# Middlesex House

Design Update Document

1759-FPA-XX-RP-A-16002-01

# Upper Roof floor Approved

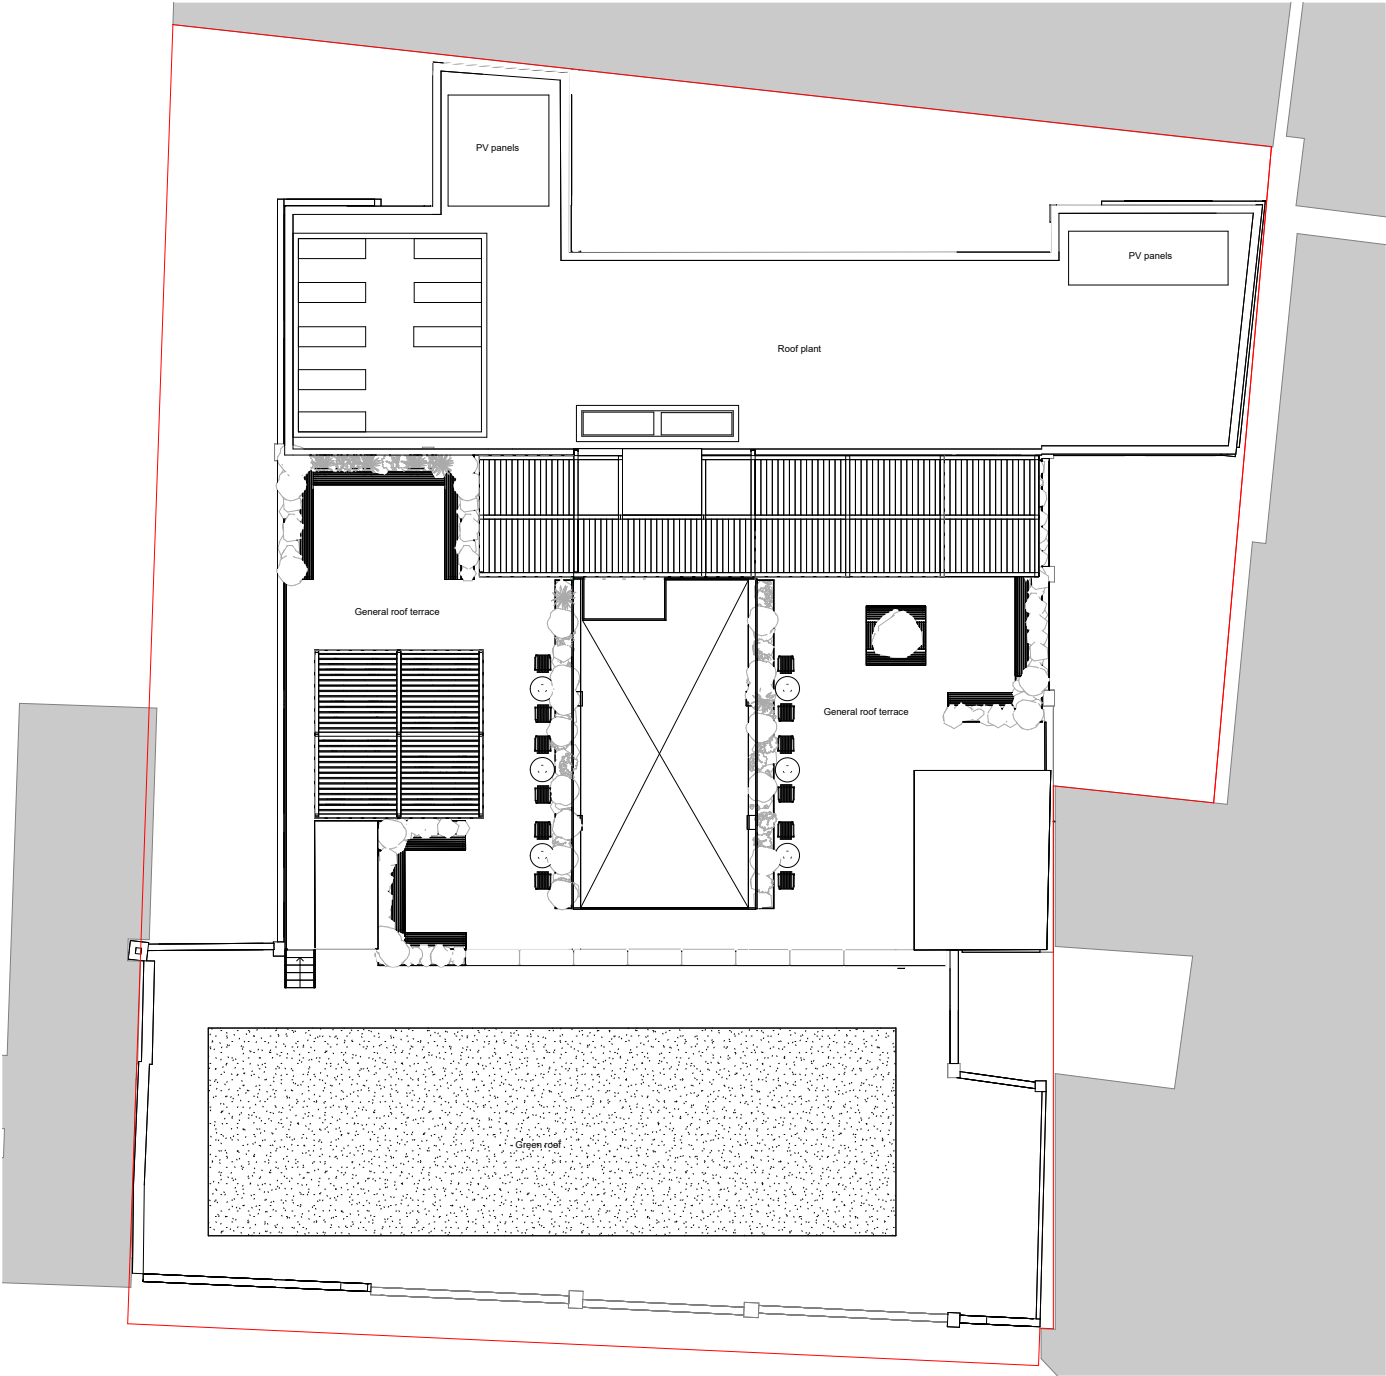
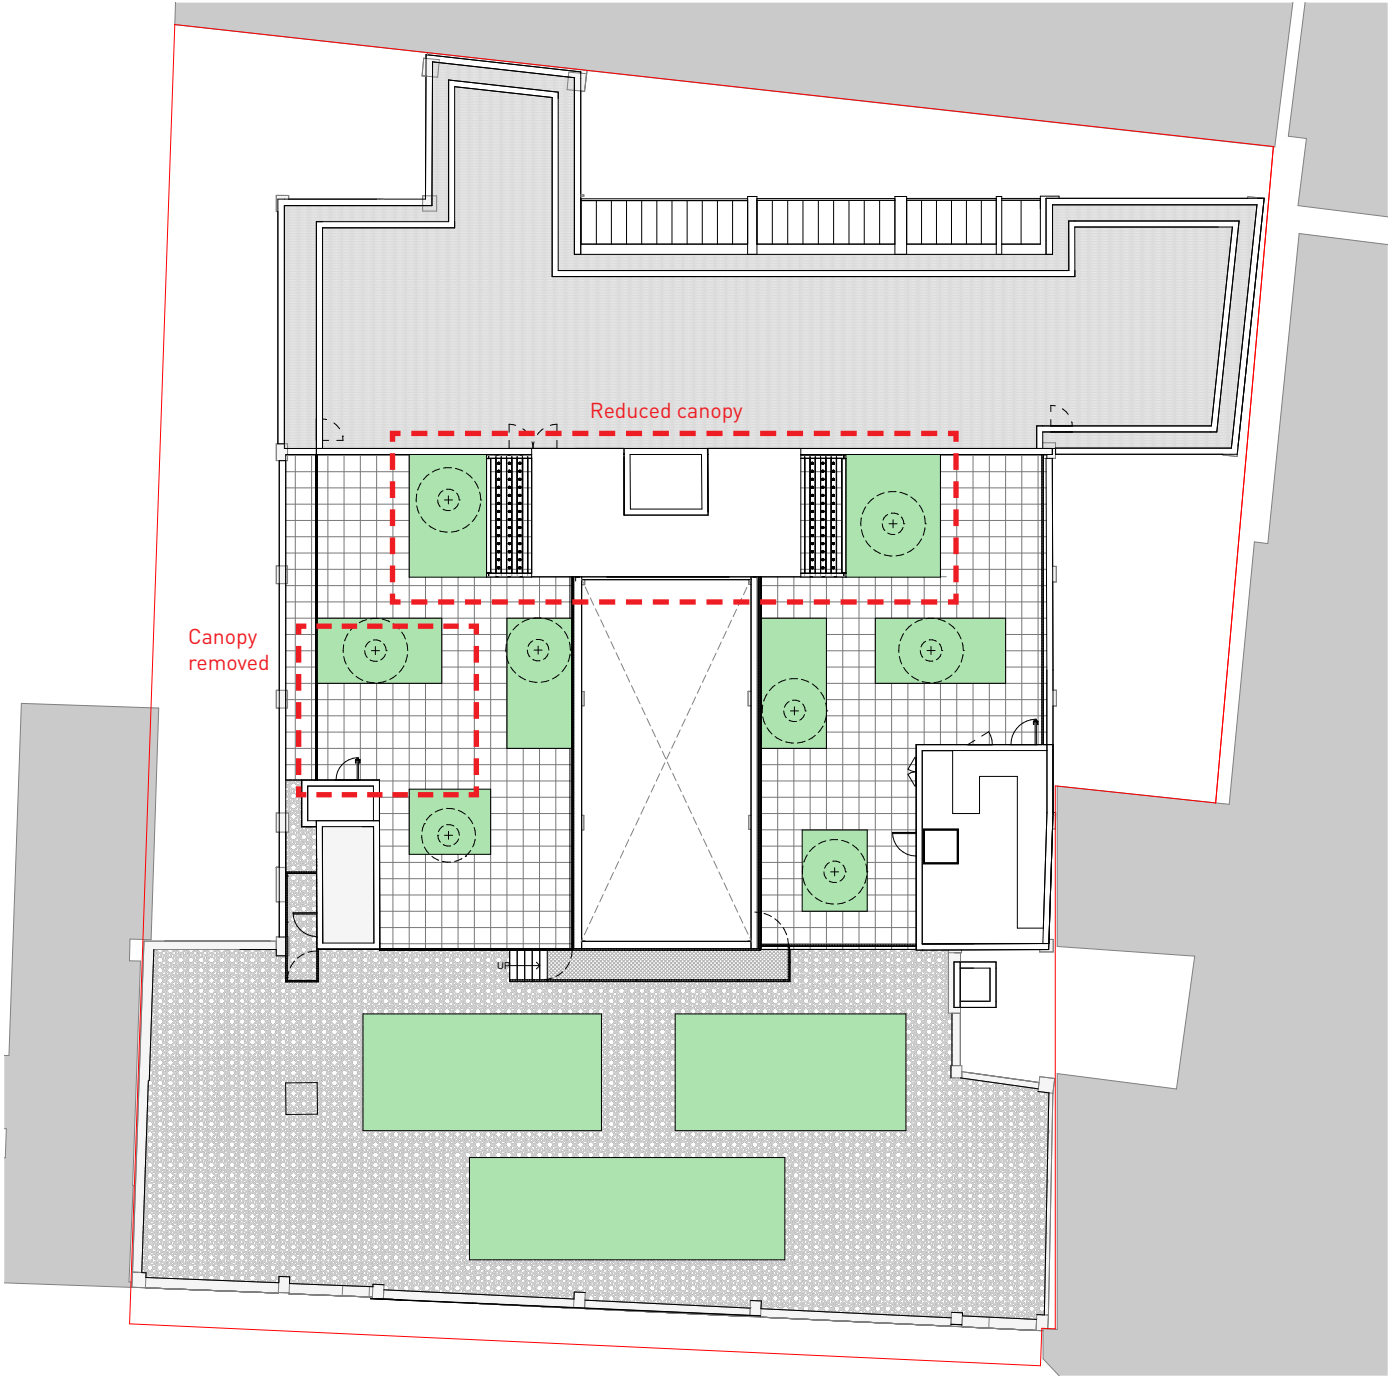
On the roof, the plant screen height is proposed to increase, which would ensure all equipment is out of sight. The terrace is proposed to have a more fluid landscape design, with fewer canopies and instead the addition of a number of trees, making it a more enjoyable view for the surrounding context. An additional superloo is proposed as well, to guarantee access to the accessible WC by those who need it.
